UK-2617.0-8-25

Ag Research Facility 1 – BP-04 Equipment

ADDENDUM # 04

UK AG Research Building
TC-025 Mechanical Equipment RFP
ADDENDUM No. 4
UK-2617.0-8-25
10/01/2024

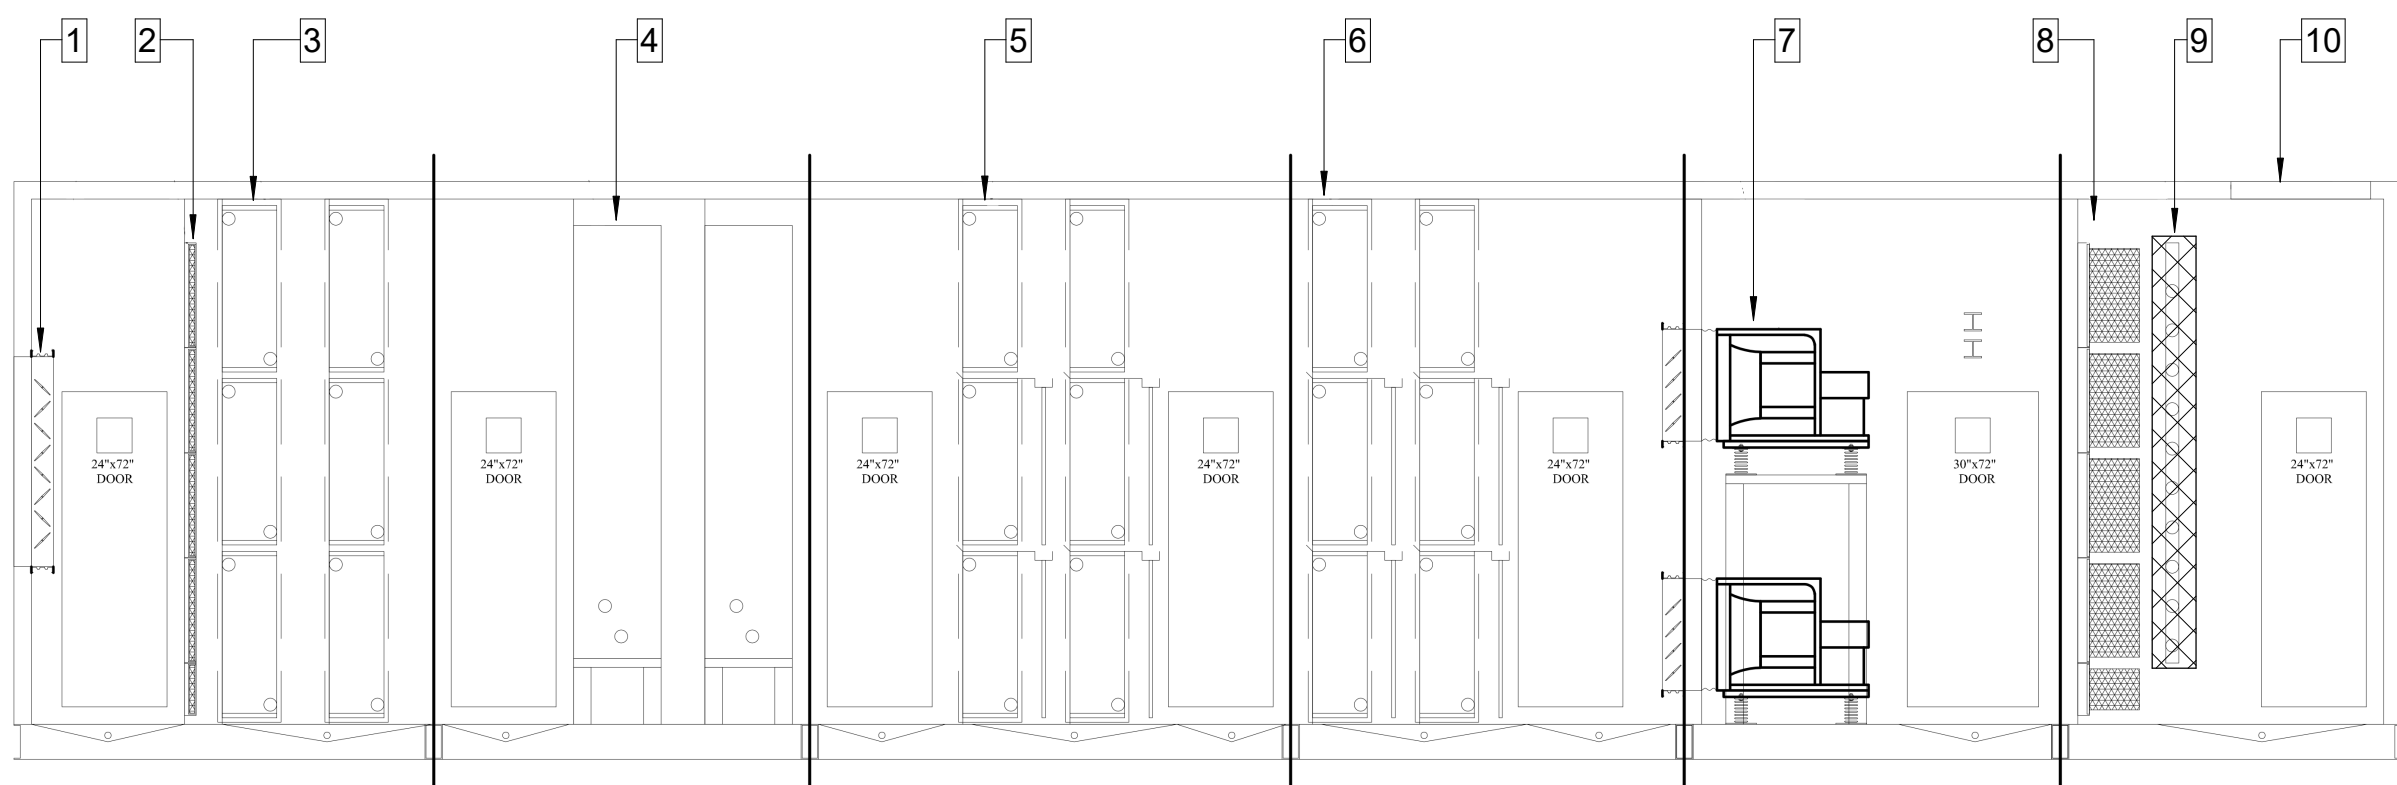
- Item 1. Sheet M702.1 - MECHANICAL SCHEDULES
- Revisions to OA-S and OA-N unit schedules.
- Item 2. Sheet M703.1 - MECHANICAL SCHEDULES
- Revisions to LEF-N and LEF-s unit schedules.
 - Revisions to LEF unit section views.

- 1 - 96"x48" OA DAMPER
- 2 - 2" PRE FILTER
- 3 - (4) HEAT RECOVERY COILS
- 4 - (2) STEAM IFB COIL
- 5 - (4) PRE COOLING COILS
- 6 - (4) COOLING COILS
- 7 - (6) SUPPLY FANS
- 8 - 12" FINAL FILTERS
- 9 - HUMIDIFIER MANIFOLD
- 10 - SUPPLY DISCHARGE
